Registry No. H11491

General Locality Eastern Prince William Sound

Sublocality Entrance to Valdez Arm

Revision Compiled During Office Processing and Certification

Figure 4. 10-meter Base surface after reaccepting outer beams.

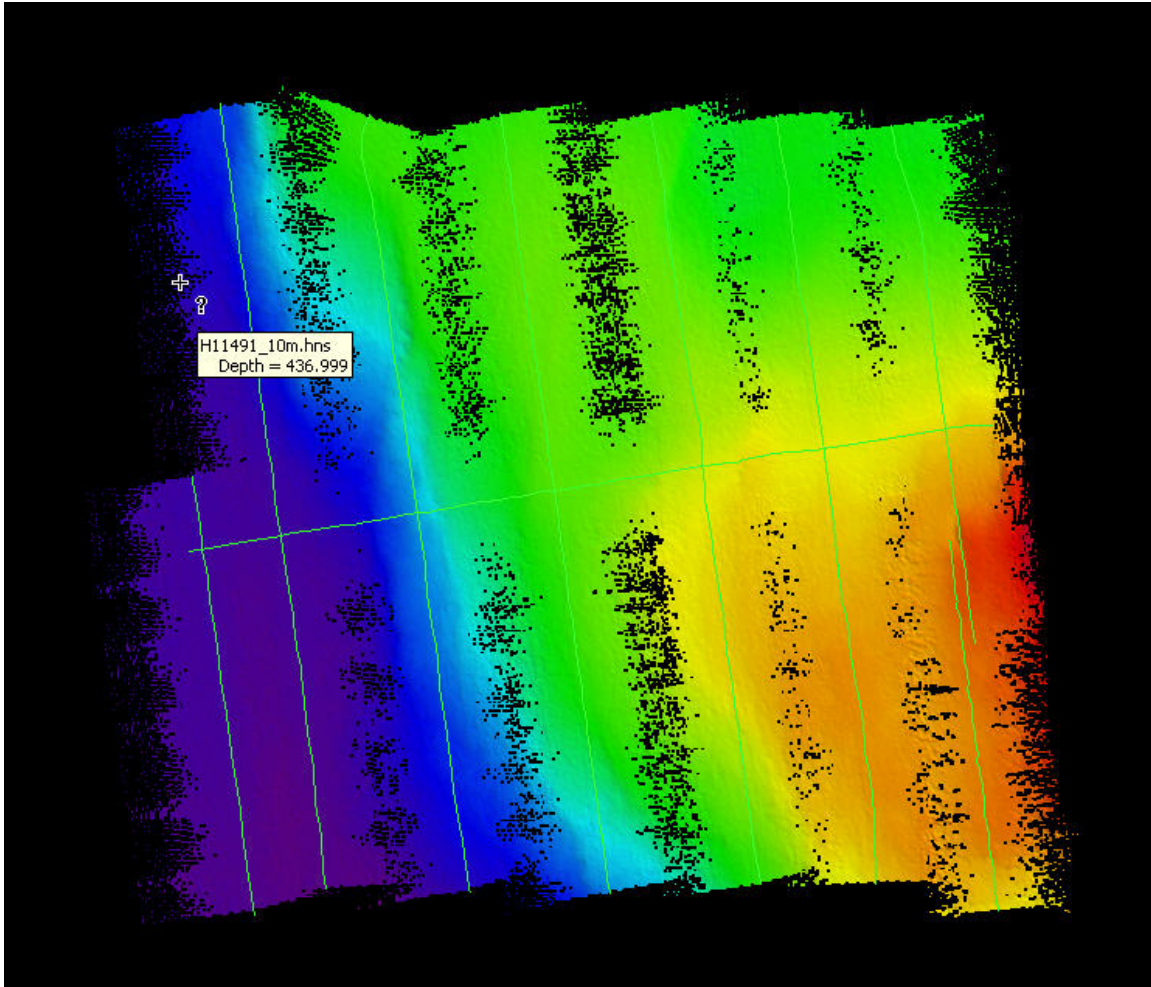
Figure 4 illustrates the 10-meter BASE surface coverage. This sparse dataset is the result of the inherent along-track coverage limitations of the Elac multi-beams, described in detail in the OPR-P132-RA-05 DAPR. Given that the depth range for survey H11491 is between approximately 275 and 455 meters and no significant features are indicated by the bathymetry, the hydrographer recommends acceptance of the 20m BASE surface as the final product of the survey.⁴

⁴ Concur. Density requirements are met for most of the survey area with a 20 meter surface. Given that the shoalest point in the survey is approximately 275 meters, this coverage density should be sufficient for compilation.
